# Proposed Heights HX Plan District Changes

# Additional HX Code Changes

**Figure 20.670-1**

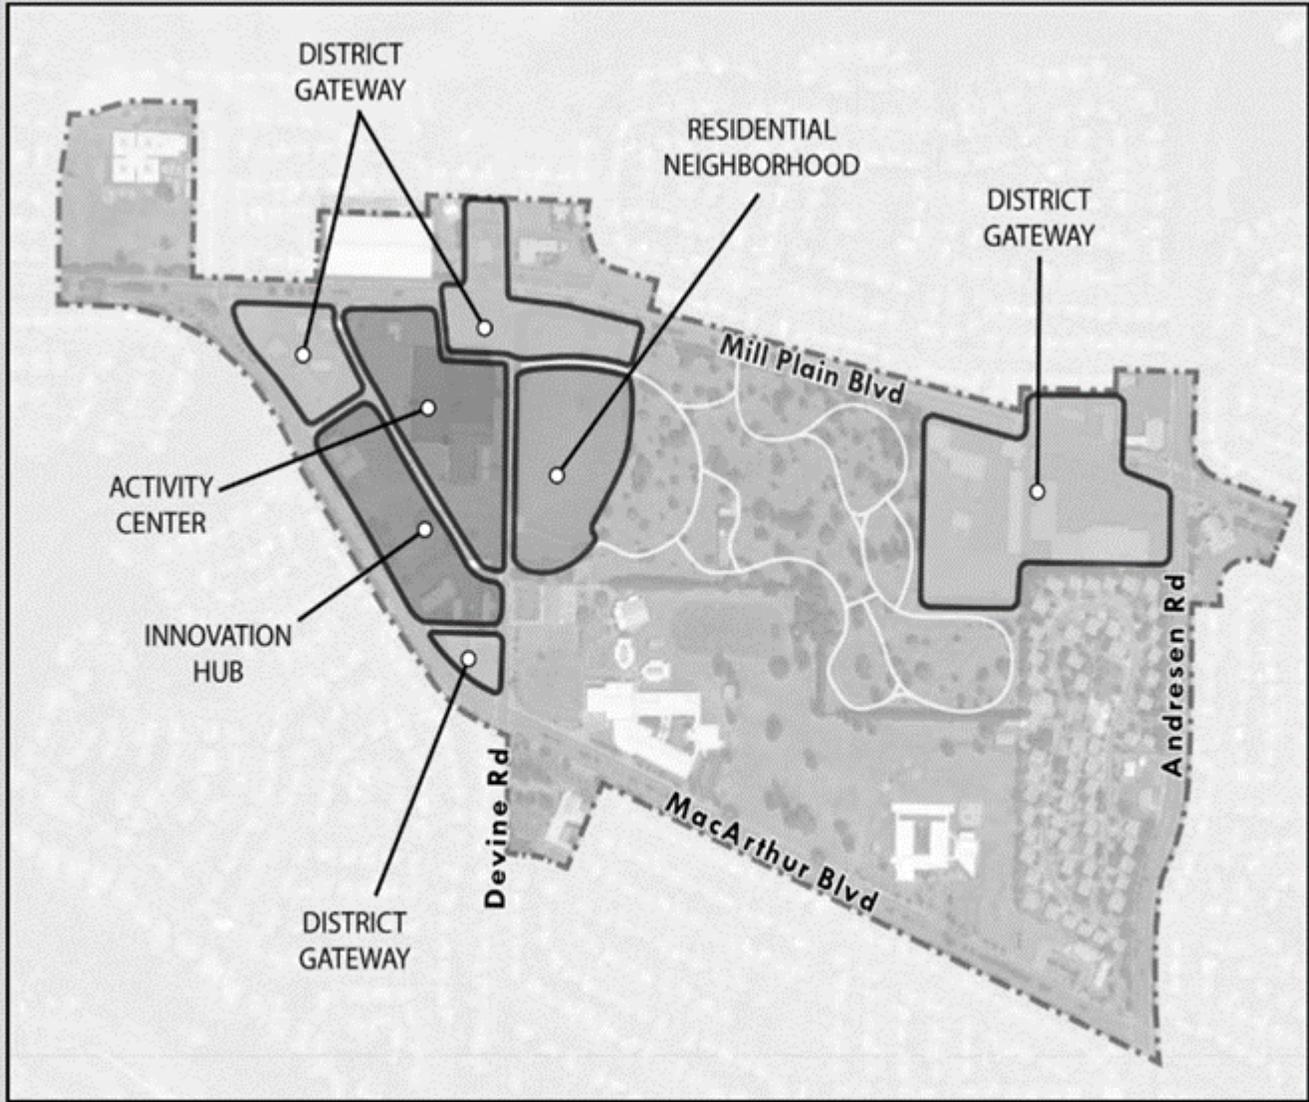
**Table 20.670.040-2** Maximum Building Heights

<b>Sub-District</b>	<b>Maximum Height</b>
Activity Center	Maximum of 85 feet
Residential Neighborhood	Maximum of 85 feet
Innovation Hub	Maximum of 50 feet
District Gateway	Maximum of <del>50</del> 55 feet not abutting residentially zoned properties
<b>Sub-District</b>	<b>Maximum Height</b>
	Maximum of 40 feet abutting residentially zoned properties
	Maximum of 35 feet fronting Idaho Street

- Increase maximum building height in the District Gateway subdistrict from 50 feet to 55 feet for properties not abutting residentially zoned properties.
- Create two definitions of commercial frontage to differentiate between active retail around the Civic Plaza and all other commercial uses.
- Modify the Ground-Floor Uses diagram to allow for all types of commercial uses (i.e. Commercial Type 2) at the Safeway site on Mill Plain Blvd. and Andresen Road.

# Revised Ground Floor Uses Map

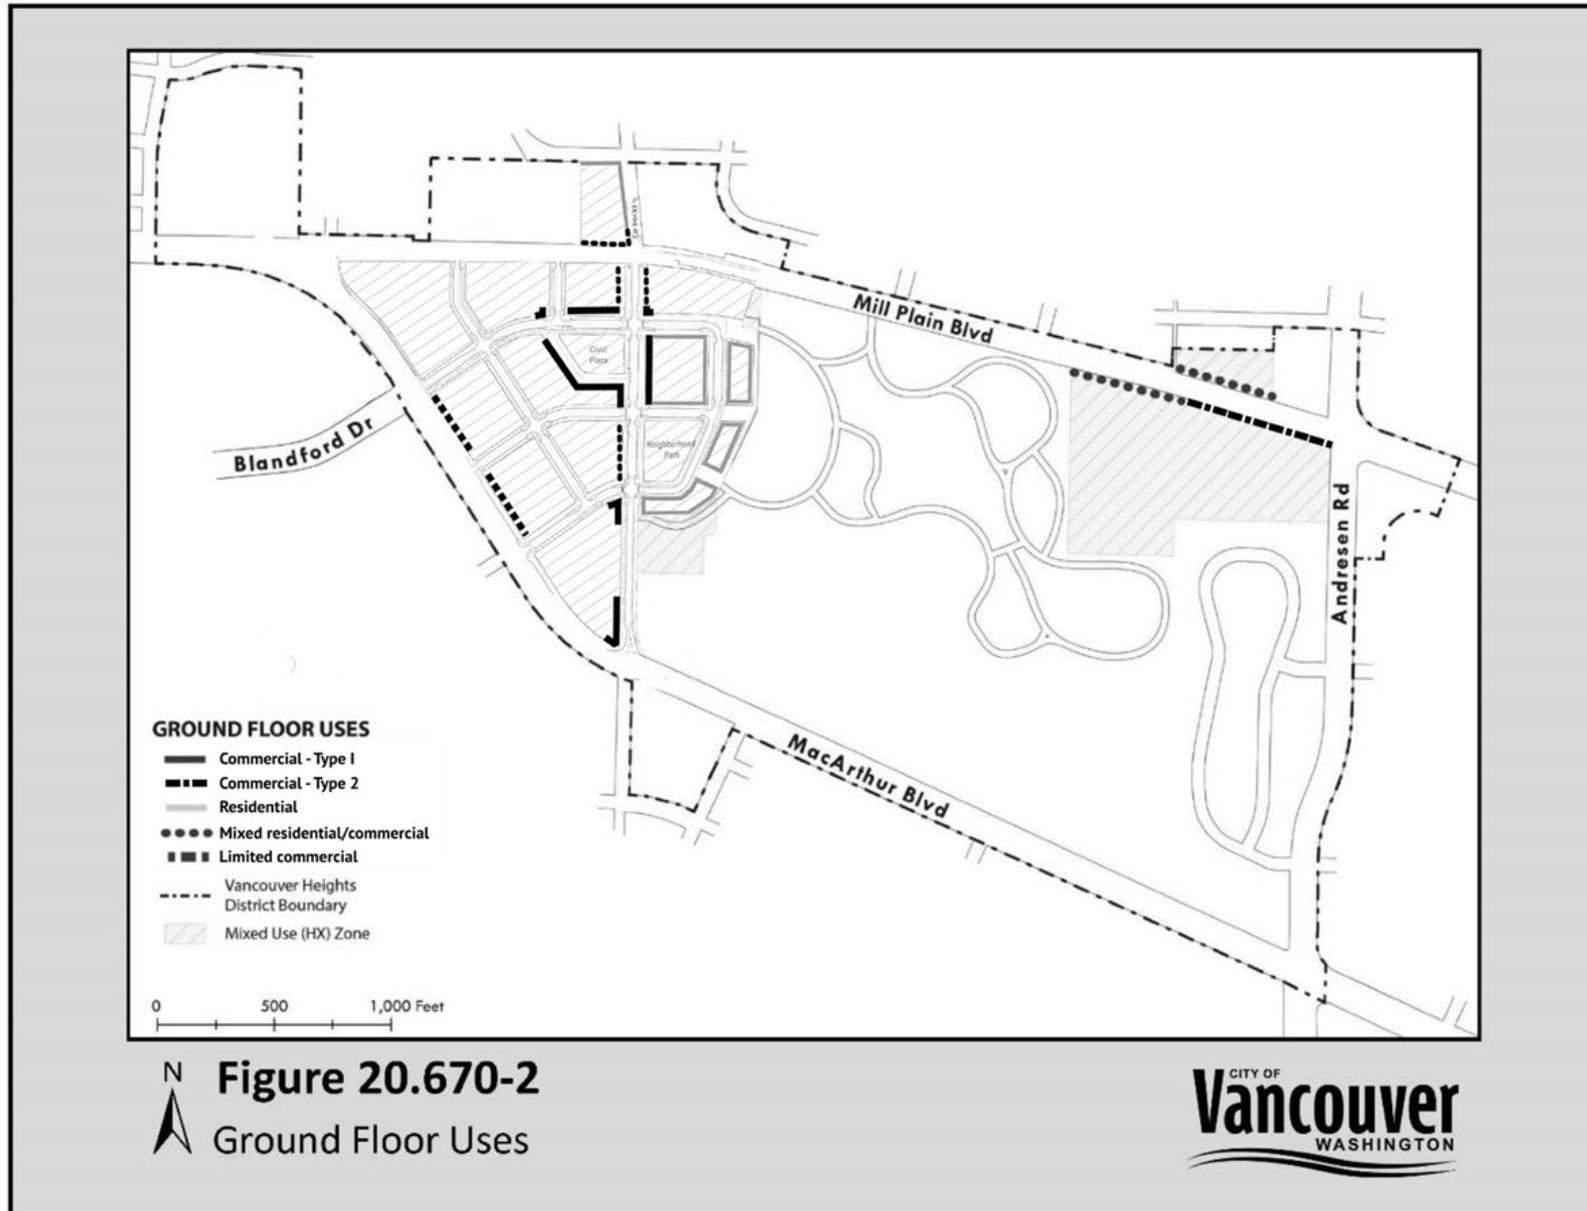
Modify the Ground-Floor Uses diagram to allow for all types of commercial uses (i.e. Commercial Type 2) at the Safeway site on Mill Plain Blvd. and Andresen Road.
